MEMORANDUM

RE: Lot 13-14 Less Lot H-1 Jones Tract and Lot 15-20, less Lot H-1 and less Tract A of Jones Tract of Block 2, NW1/4NW1/4 Jones Tract, Section 2, T1N, R7E, BHM, Rapid City, Pennington County, South Dakota, also described as 1935 W. Main Street

**RE: Request for Deviation from Design Criteria, Proposed Fuel Facility
1935 W. Main St., Rapid City, SD**

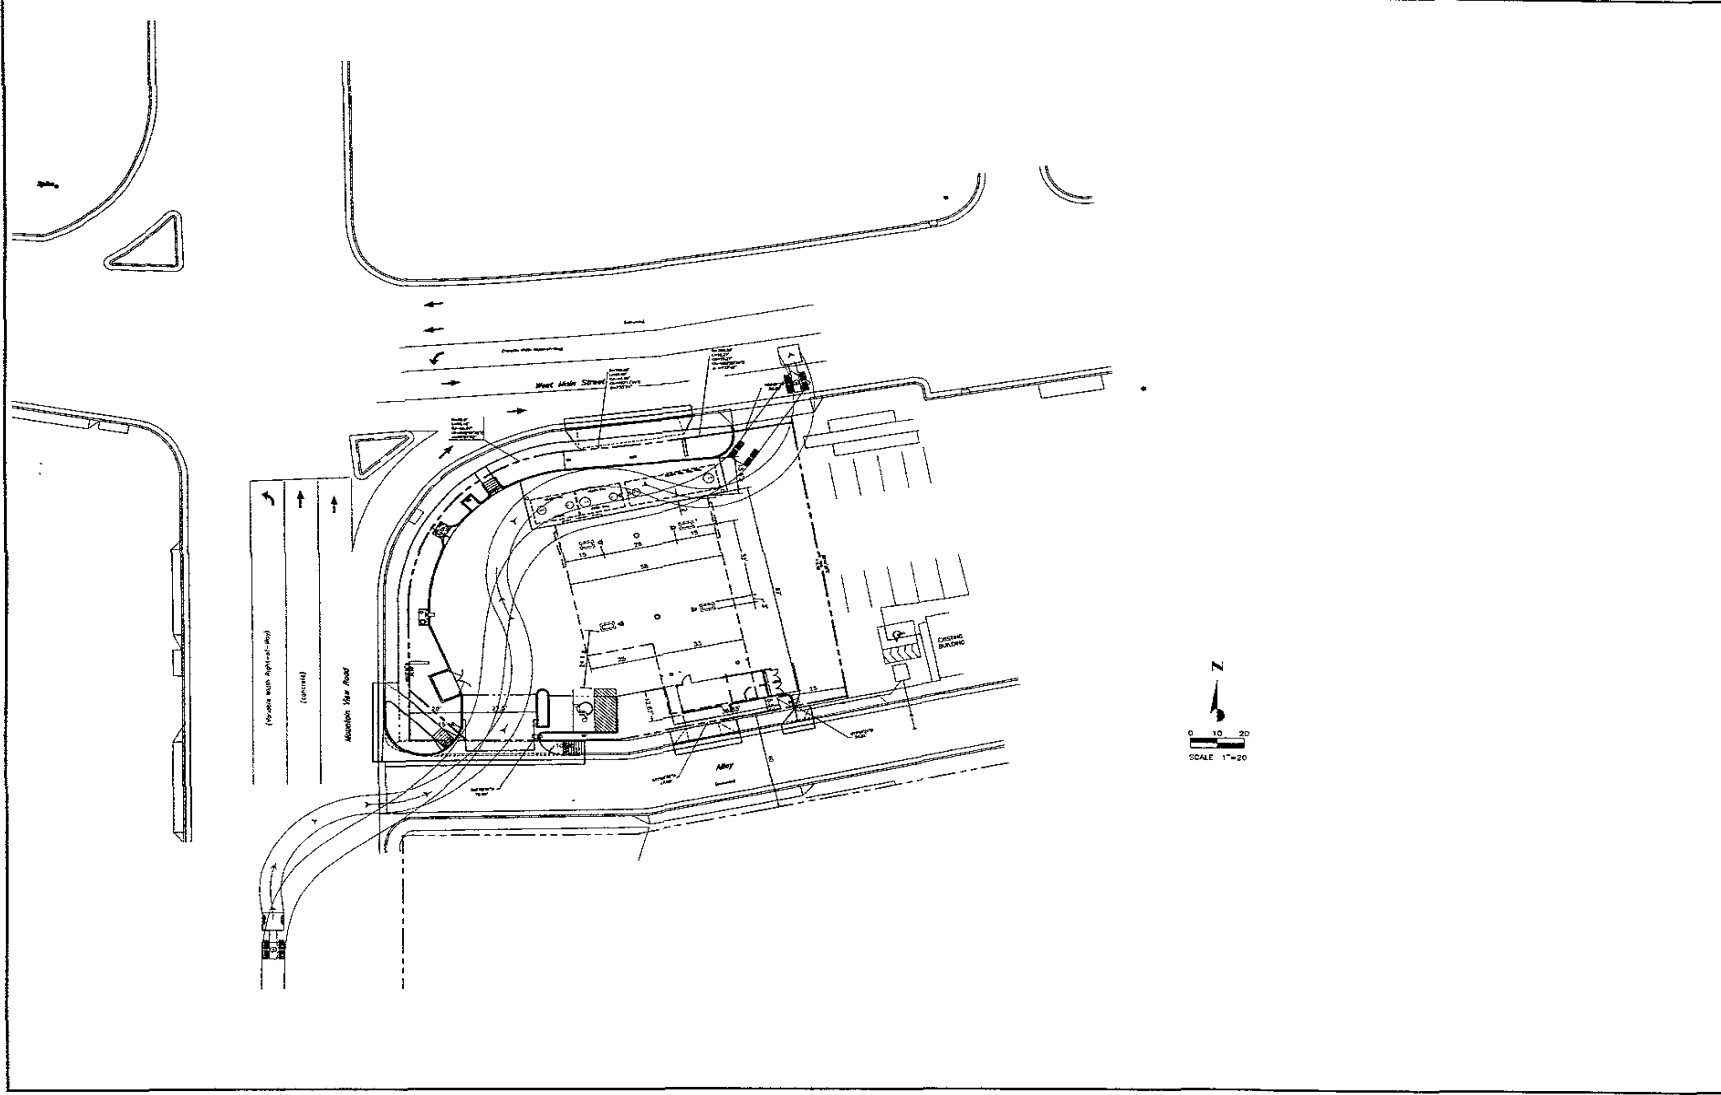
Thank you for taking the time to discuss this project with me on the phone the other day. I had called you in reference to your review comment made on December 13, 2004 in regards to the new access point along the southerly property line. The comment we discussed was "*New access in alley near intersection with Mt. View is too close, needs to be 115 ft from intersection.*" Per that conversation, this letter will serve to further explain/justify the location of that access point, to provide you with additional information and to request a deviation to Rapid City's design criteria.

- The proposed access point from the alley along the southerly property line will replace an existing access point off of Mountain View Road. That existing access point is a 20’ wide full motion curb cut that parallels the existing alley. These two access points are virtually right on top of one another as the distance between the northerly edge of the alley and the southerly edge of the existing curb cut is approximately 6 feet. Both of these access points currently allow both left and right turning vehicles to exit onto Mountain View Road as well as accepting north and southbound turning vehicles off of Mountain View Road. This is a very dangerous situation and while we have to have a means of accepting northbound traffic off of Mountain View Road for tanker fueling purposes, we feel that keeping the existing Mountain View Road curb cut is a less than desirable choice. We thought about relocating this curb cut a little further to the north but realized that we would only be compounding the existing problems. Currently, the northerly line of the existing curb cut is approximately 100’ south of the southerly flowline of W. Main Street. This is less than the desired clearance of 115’ and relocating the curb cut would only reduce this distance.

- We realize that having the proposed curb cut close to Mountain View Road could cause less than desirable situations at times but we feel that closing the existing curb cut onto Mountain View Road outweighs those potential situations. As we discussed, the few vehicles that will exit the site through this proposed curb cut could potentially be blocked by vehicles in then alley that are exiting onto Mountain View Road.

Staff Recommendation: Staff recommends that an Exception be granted to reduce the separation between the arterial street and the alley driveway from 50 feet to 40 feet as per the Street Design Criteria Manual.

improved the internal operational circulation of the facility. We respectfully request a deviation from the City of Rapid City's design criteria that will allow us to construct the access point along the southerly property line as shown on the enclosed Enlarged Site Plan.

SHEET TITLE
TANKER ACCESS PLAN

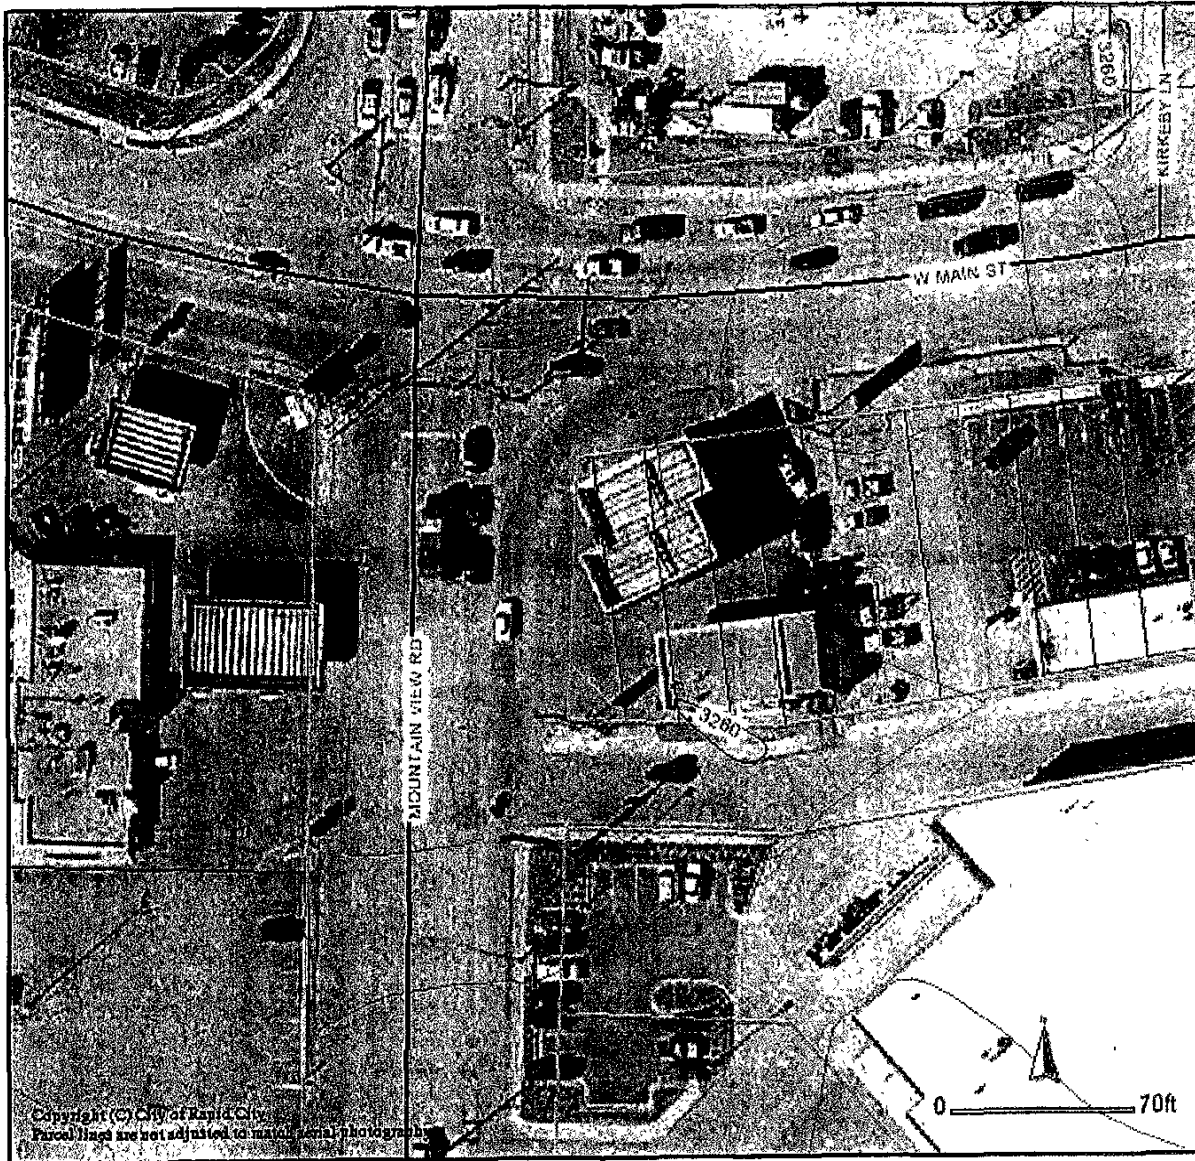
- The proposed access point off of the alley along the southerly property line will be the primary access point for tanker fueling and the curb cut is needed for that purpose. We anticipate tankers approaching the site from the south and exiting onto W. Main Street as indicated on the enclosed Tanker Access Plan. The site is too small to accept tankers from the curb cuts along the easterly property lines and have the tankers loop through the site. We anticipate that the underground storage tanks will be filled during non-peak hours.
